Bayside Planning Panel

Item No	6.6
Application Type	Development Application
Application Number	DA-2017/307
Lodgement Date	23 March 2017
Property	28 Alfred Street, Ramsgate Beach
Owner	Ramsgate Beach Pty Ltd
Applicant	Space 0.618:1
Proposal	Construction of a two (2) storey attached dual occupancy development, including rooftop terrace, front fence, demolition of existing structures and Torrens title subdivision creating two lots
No. of Submissions	Three (3) submissions
Cost of Development	\$ 625,000.00
Report by	Adam Iskander, Development Assessment Planner

Planning Assessment Report

Application Number:	DA-2017/307
Date of Receipt:	23 March 2017
Property:	28 Alfred Street, RAMSGATE BEACH (Lot X DP 390114)
Owner:	Ramsgate Beach Pty Ltd
Applicant:	Space 0.618:1
Proposal:	Construction of a two (2) storey attached dual occupancy development, including rooftop terrace, front fence, demolition of existing structures and Torrens title subdivision creating two lots
Recommendation:	Approved
No. of submissions:	Three (3)
Author:	Adam Iskander
Date of Report:	13 February 2018

title:
WINTER 9AM
ELEVATION
SHADOW

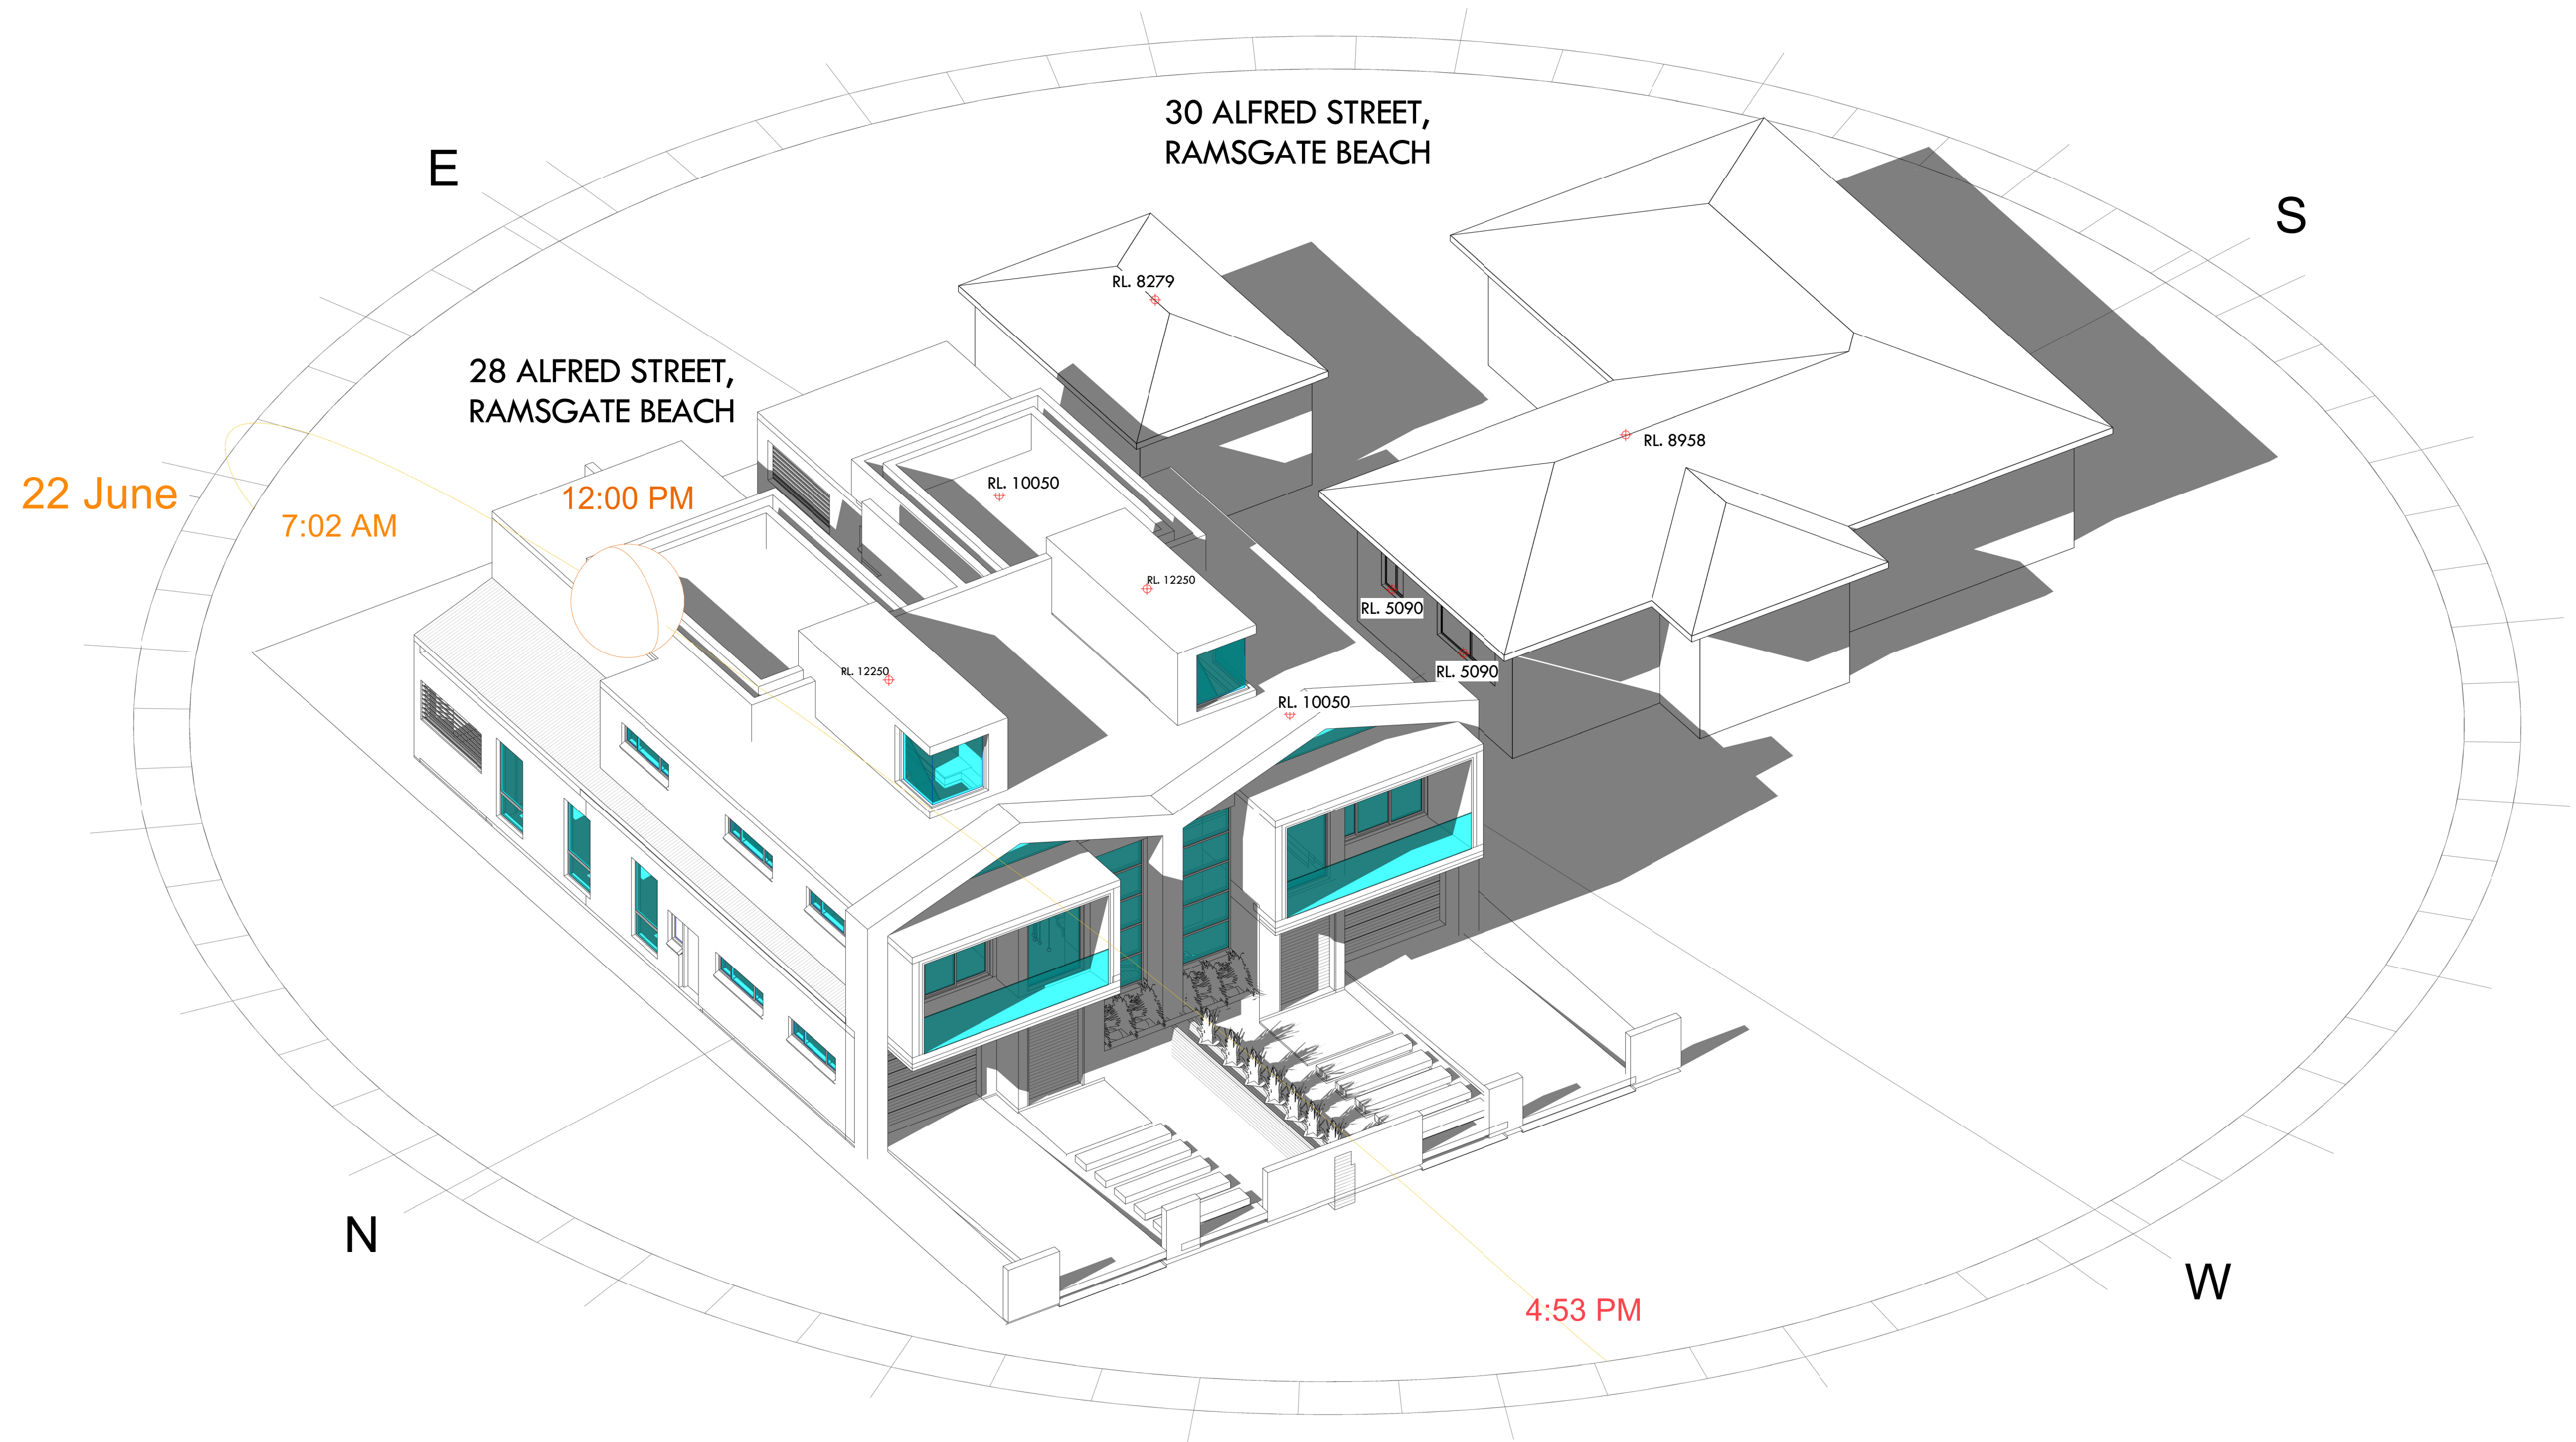
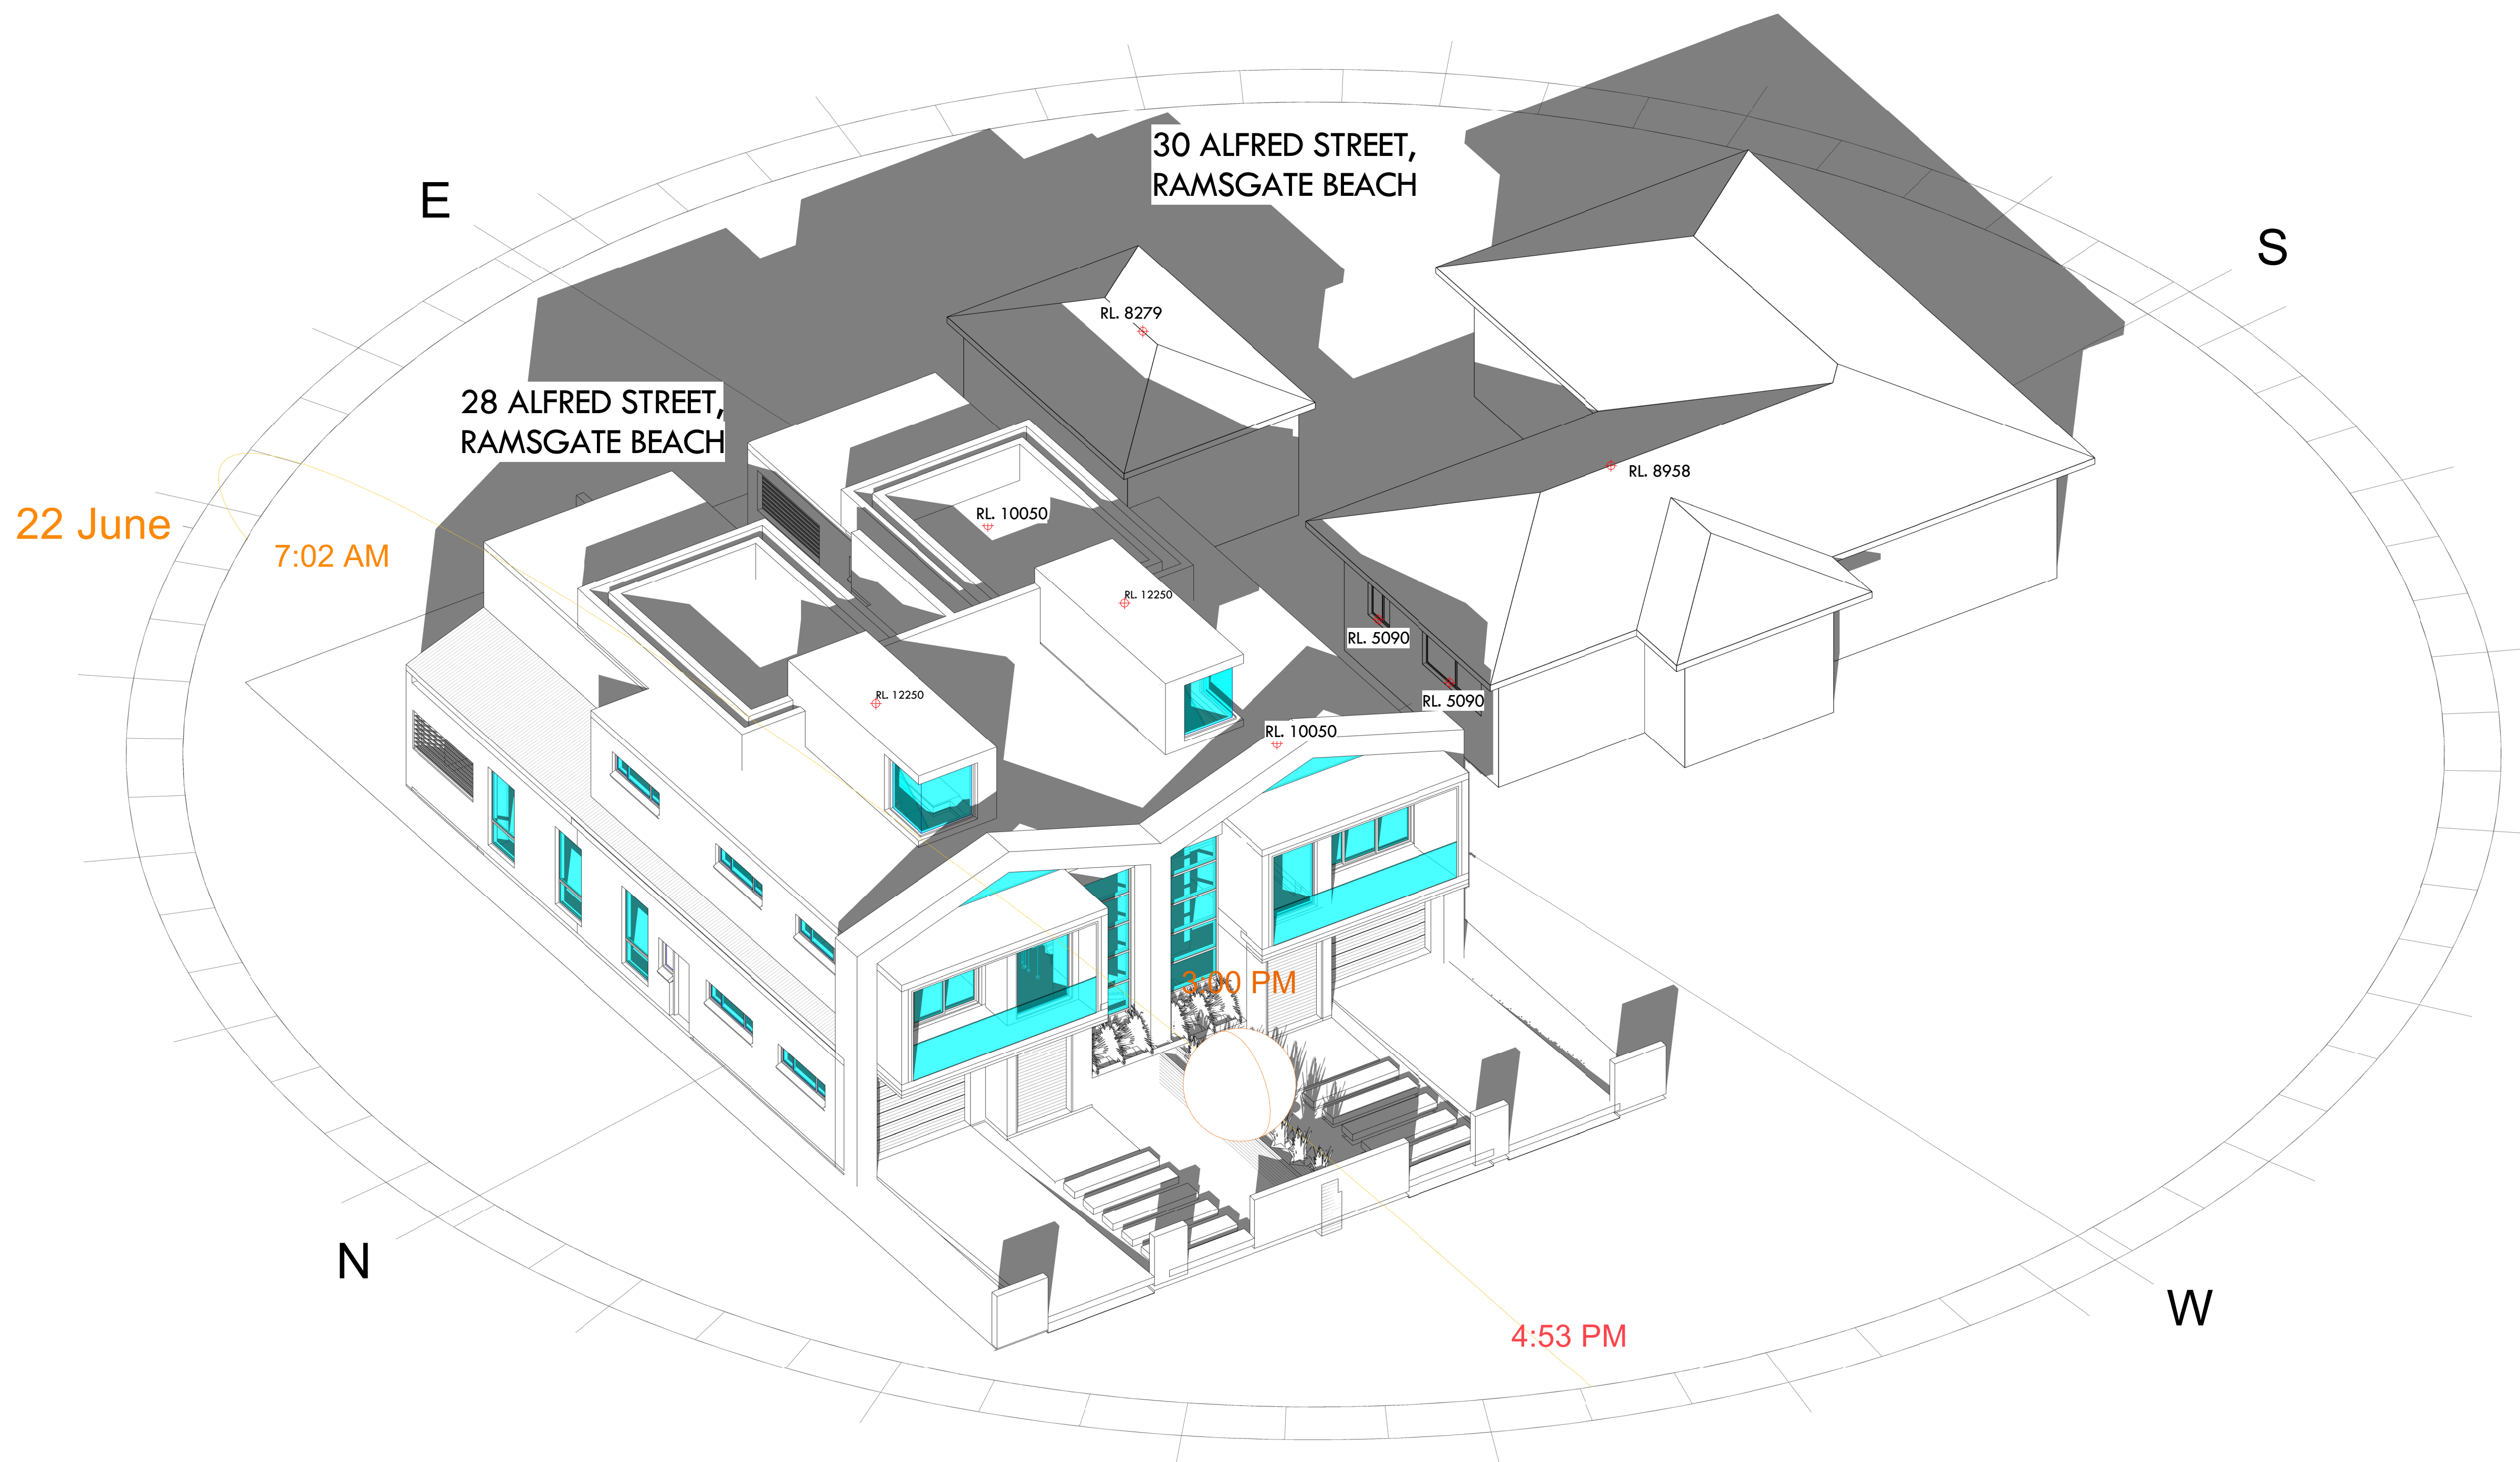
The adjoining dwelling to the south is situated on a property that has an east-west orientation. The applicant has submitted shadow diagrams for 9 a.m., 12 p.m. and 3 p.m. on June 21. The shadow diagrams show that the adjoining windows will not receive the prescribed amount of sunlight, however at least 50% of the private open space will receive sunlight.

The 3D scale shadow diagrams show that at 9am entire yard and rear windows of the adjoining southern neighbour will receive solar access and the front facing windows of the dwelling will receive solar access at 3pm.

The adjoining dwelling to the south is situated on a property that has an east-west orientation. The applicant has submitted shadow diagrams for 9 a.m., 12 p.m. and 3 p.m. on June 21. The shadow diagrams show that the adjoining windows will not receive the prescribed amount of sunlight, however at least 50% of the private open space will receive sunlight.

The 3D scale shadow diagrams show that at 9am entire yard and rear windows of the adjoining southern neighbour will receive solar access and the front facing windows of the dwelling will receive solar access at 3pm.
